CP-200800057
Log # TXX-08008

SUBJECT: COMANCHE PEAK STEAM ELECTRIC STATION
DOCKET NOS. 50-445 AND 50-446
SUPPLEMENT TO LICENSE AMENDMENT REQUEST (LAR) 07-004
REVISION TO THE OPERATING LICENSE AND TECHNICAL SPECIFICATION 1.0,
"USE AND APPLICATION" TO REVISE RATED THERMAL POWER FROM 3458 MWT
TO 3612 MWT
(TAC NOS. MD6615 AND MD6616)

RESPONSE TO REQUEST FOR ADDITIONAL INFORMATION

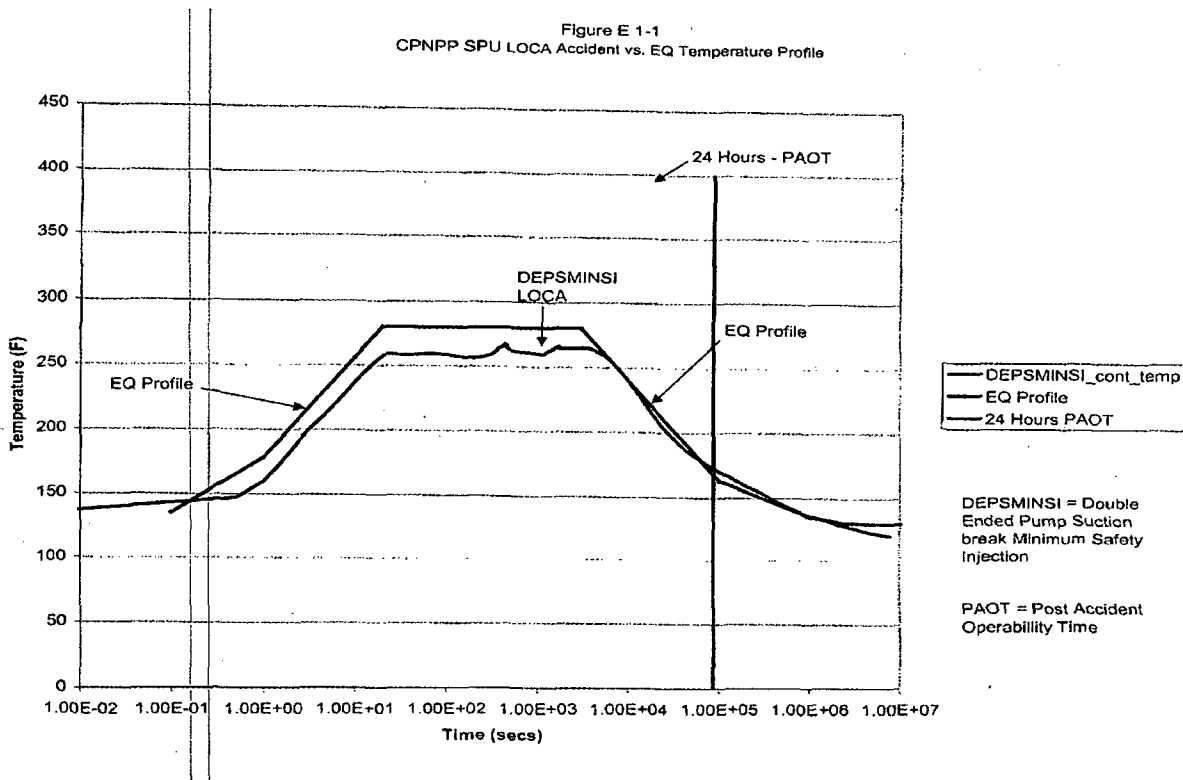
NRC Question 1.

In Section 2.3.1.2.2 of the SPULR, "Inside Containment," it is stated that at SPU, the containment analysis of design basis accidents (DBAs) demonstrates that the equipment qualification (EQ) for peak temperature remains bounded by the current EQ profile. However, the long-term temperature slightly exceeds the current profile at limited time later in the transient after the peak temperature has been reduced.

Provide details of the long-term temperature impact and the temperature evaluation done for DBA conditions.

The peak SPU LOCA temperature of 266.1 degrees Fahrenheit (°F) is reached at approximately 446 seconds (DEPSMINSI curve on Figure E 1-1 below). As shown on Figure E 1-1, a new EQ profile has been issued that extends the time duration at 280 °F so that it envelopes the new SPU LOCA curve and specifically the area that had exceeded the old EQ profile. This new EQ profile is being added to the EQ Packages as part of the CPNPP EQ package update using the plant EQ procedure. The PAOT impact is minor, since there is only a 7 °F difference between the SPU LOCA curve (170 °F) and the intersection point of the EQ profile (163 °F) at the 24 hour mark.

Siemens Power Generation Updated Main Generator Capability Curve

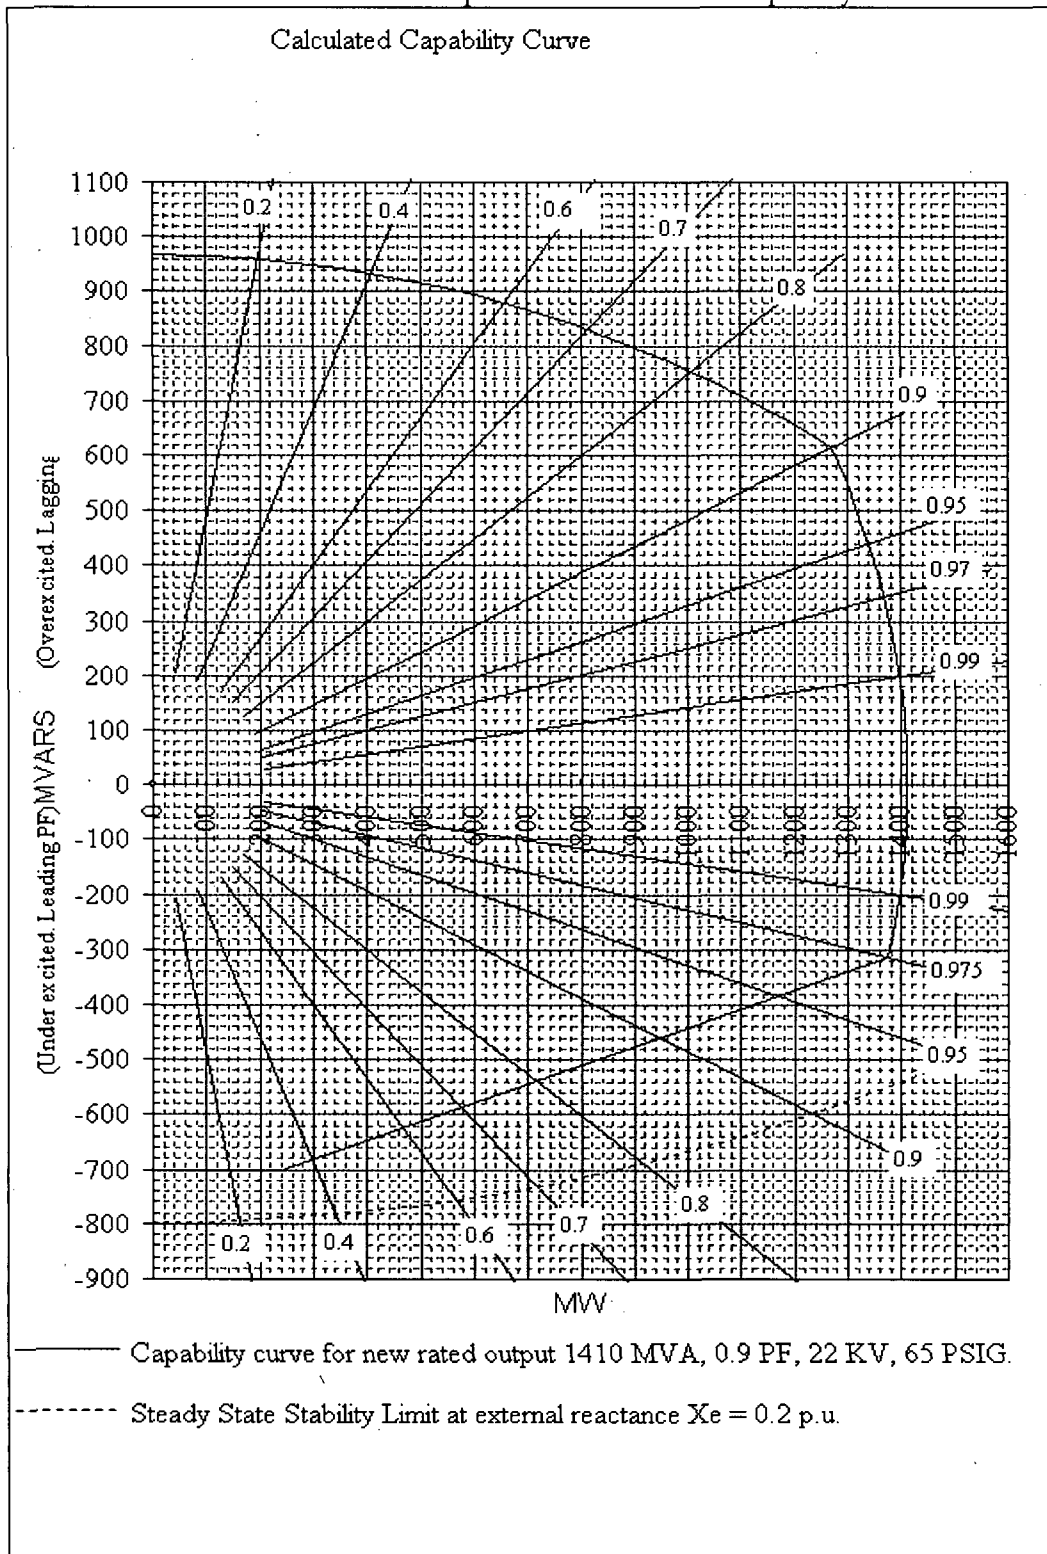
Provide the nominal or approximate megawatt generation of the CPSES units before and after the SPU. Provide a copy of the updated main generator capability curve.

Also, please find below the Siemens Power Generation updated Main Generator capability curve.
